CLIENT	ABTAP LTD
LOCATION/PROJECT	322A St Albans Road, Watford, Herts, WD24 6PQ.
TITLE OF DRAWING	Proposed Floor Plans

DESCRIPTION OF PROPOSED WORKS	Proposed extension to side at rear, with flat roof and 2 off roof lights, alterations to elevations to existing property. Vacant space at ground floor level and change of use to office
DRAWING STATUS	For Planning

DATE	Aug 2018	DRAWN BY	K O'C
SCALE	1:50	REVISIONS	D
DRAWING NUMBER	PL-3000	A1 SIZE DRAWING	
Print Drawing at 1:50 for A1 size

Proposed Ground Scale 1:50

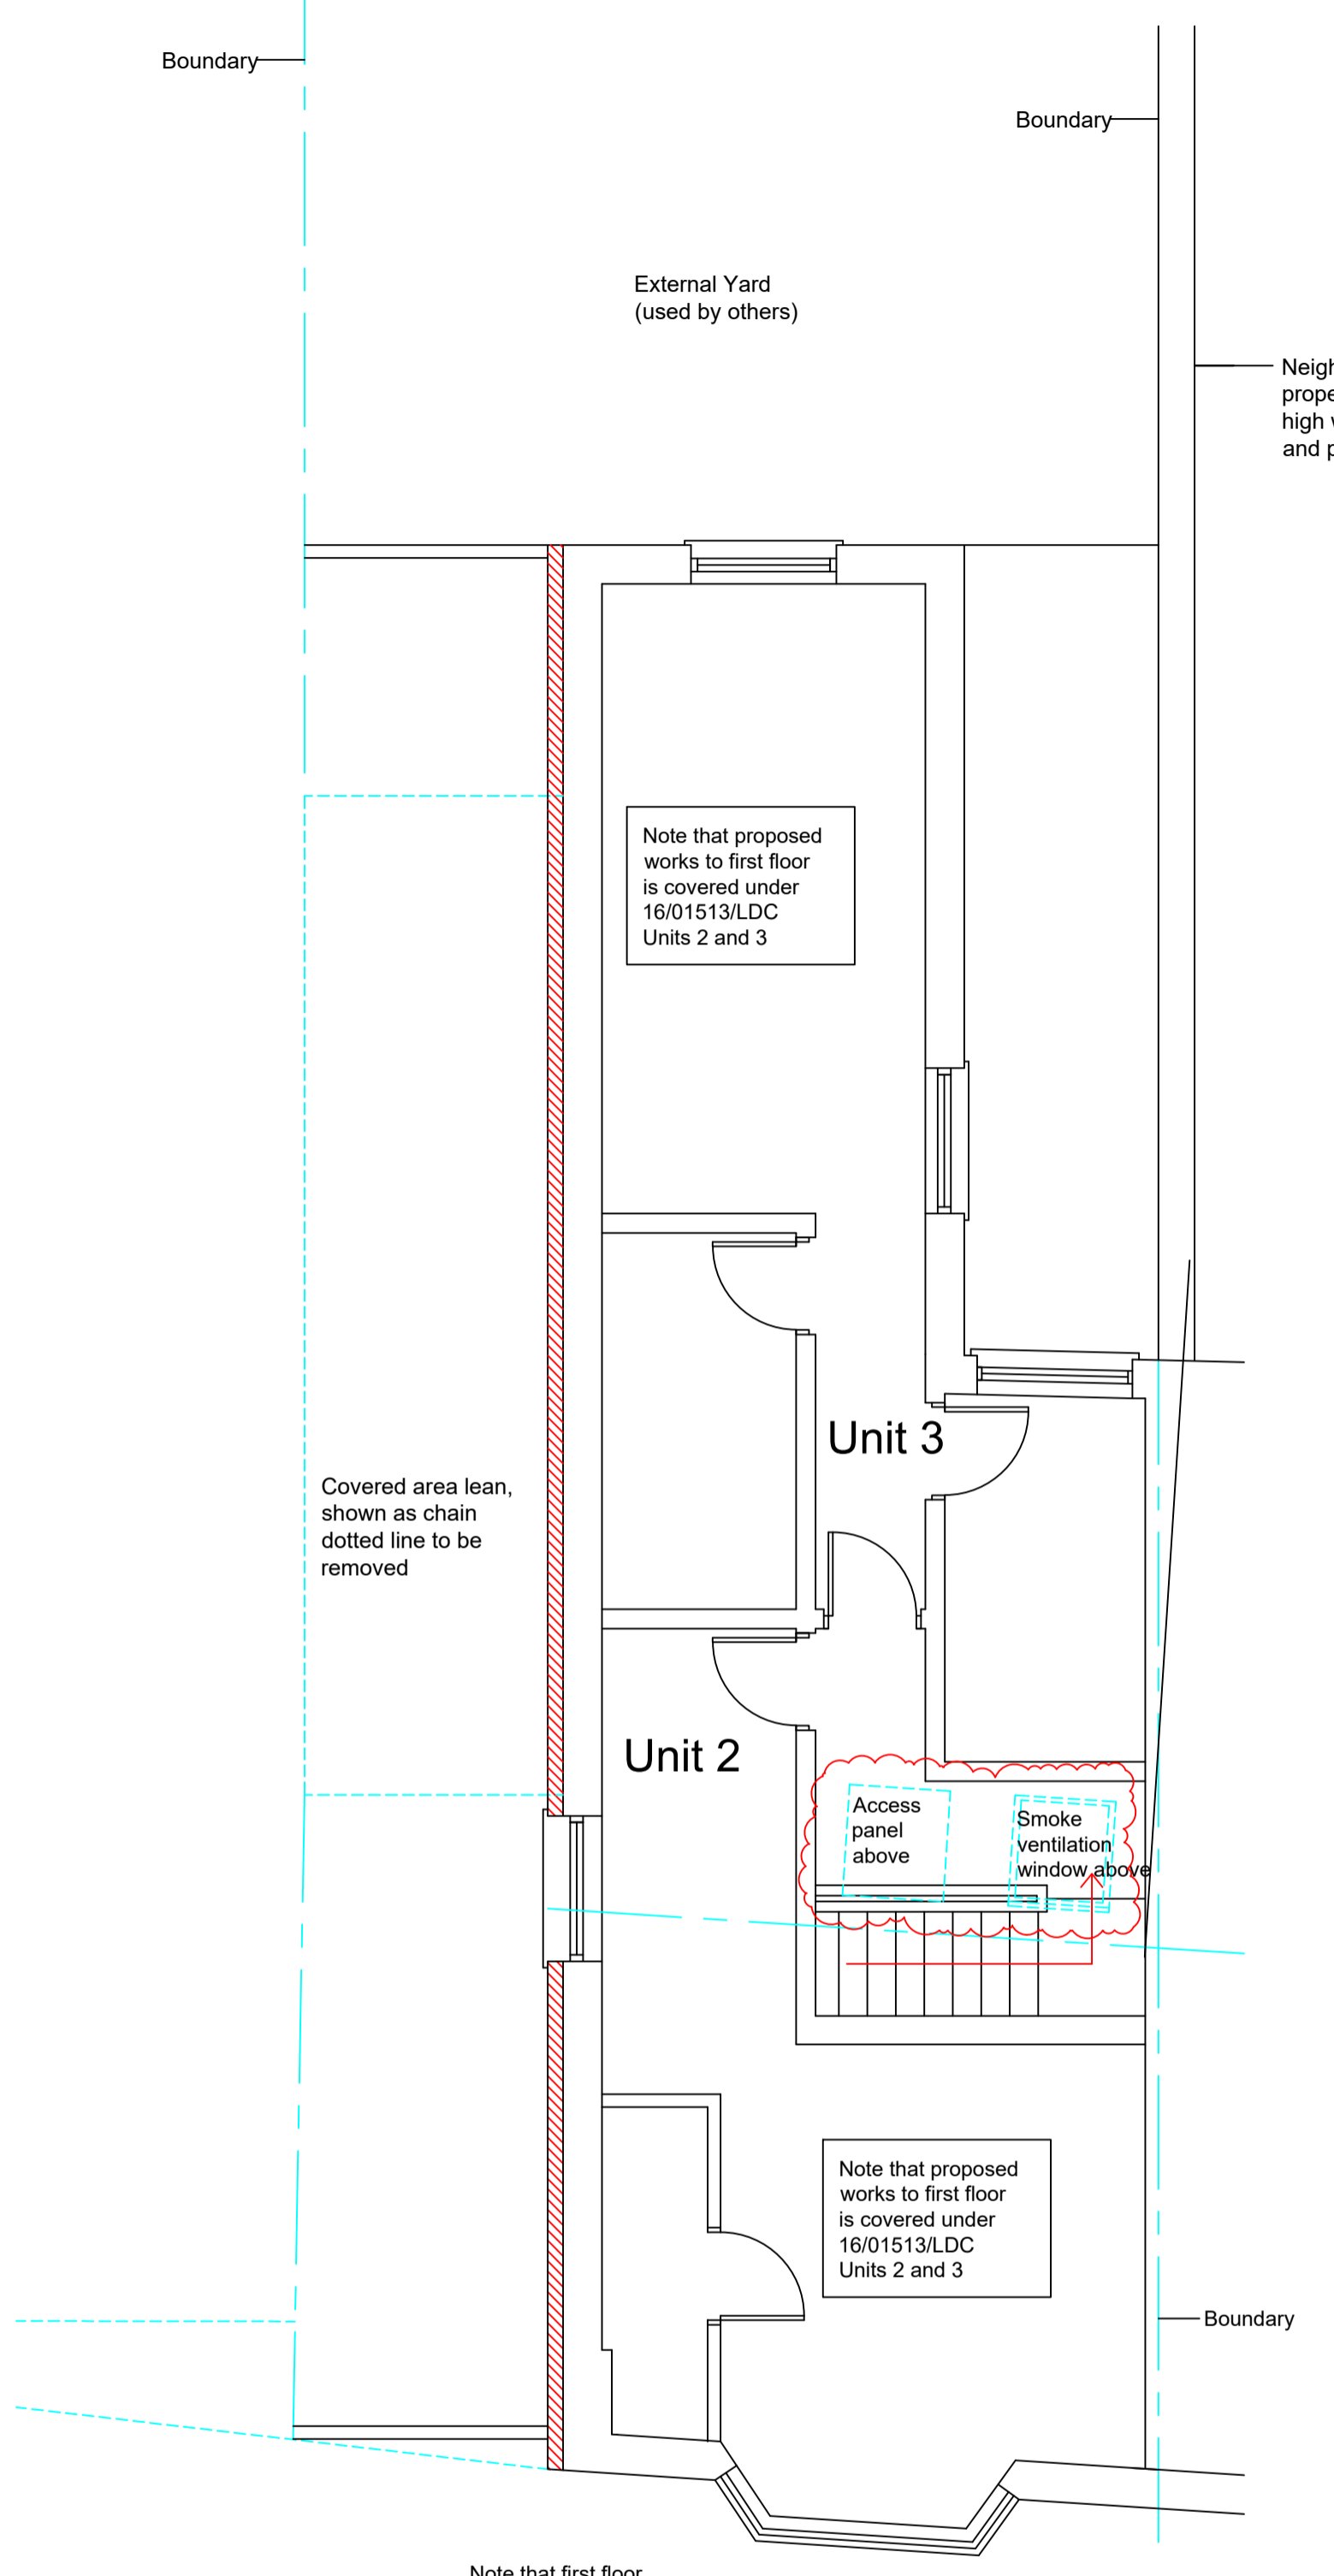
REV	DESCRIPTION	DATE	BY
A	Application revised to show existing vacant space at ground floor level and change of use to office	Oct 2018	K O'C

Proposed Roof Plan Scale 1:50

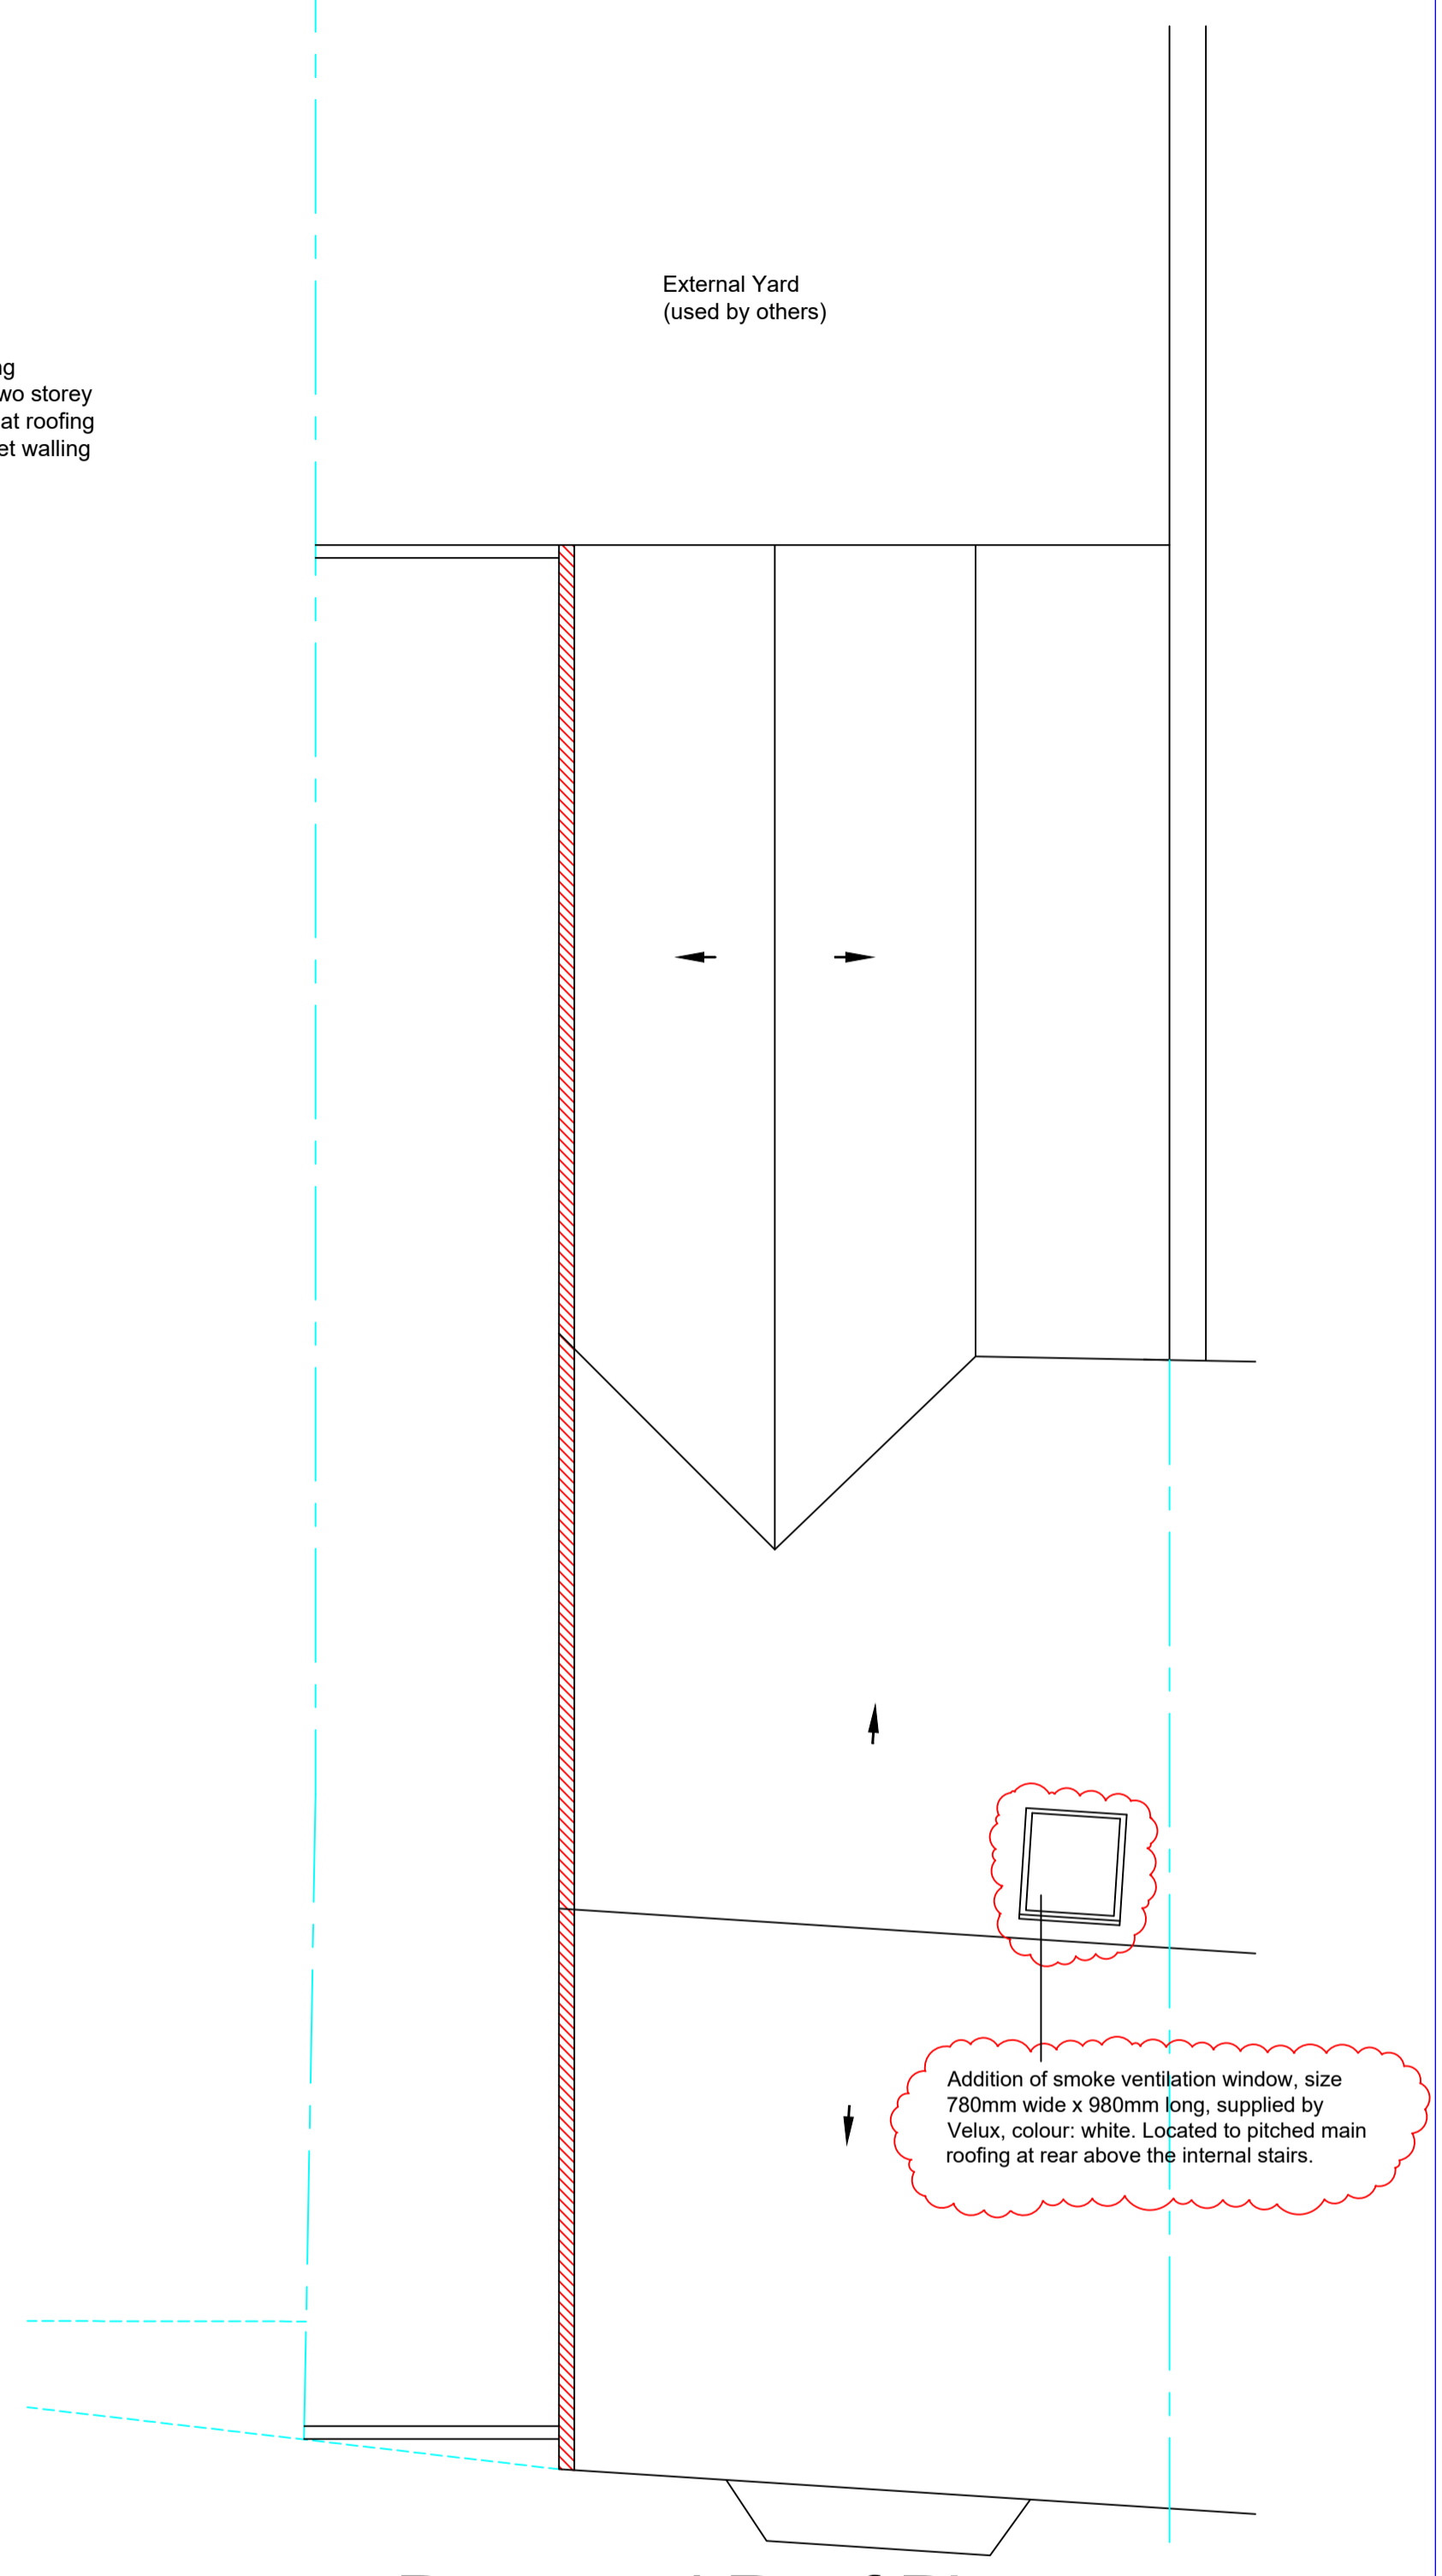
REV	DESCRIPTION	DATE	BY
C	Removal of 2 off flat roof lights, addition of proposed new windows to rear elevation	MAR 2023	K O'C

REV	DESCRIPTION	DATE	BY
D	1/ Addition of render finish to all the elevations being the rear, sides and front, also render type to be silicone render all the elevations (self finish, not painted) colour: off white. Refer to EWIPRO (external wall insulation system) thin coat render colour chart 1.5mm gain size, colour Porcelain 28010, refer to paper copy submitted and sample. Revised plans submitted PL-3000 REV D & PL-4000 REV D. Note that previous render to gable was painted finish, now silicone finish self finish Porcelain 28010. 2/ Addition of smoke ventilation window, size 780mm wide x 980mm long, supplied by Velux, colour: white. Located to pitched main roofing at rear above the internal stairs.	FEB 2024	K O'C
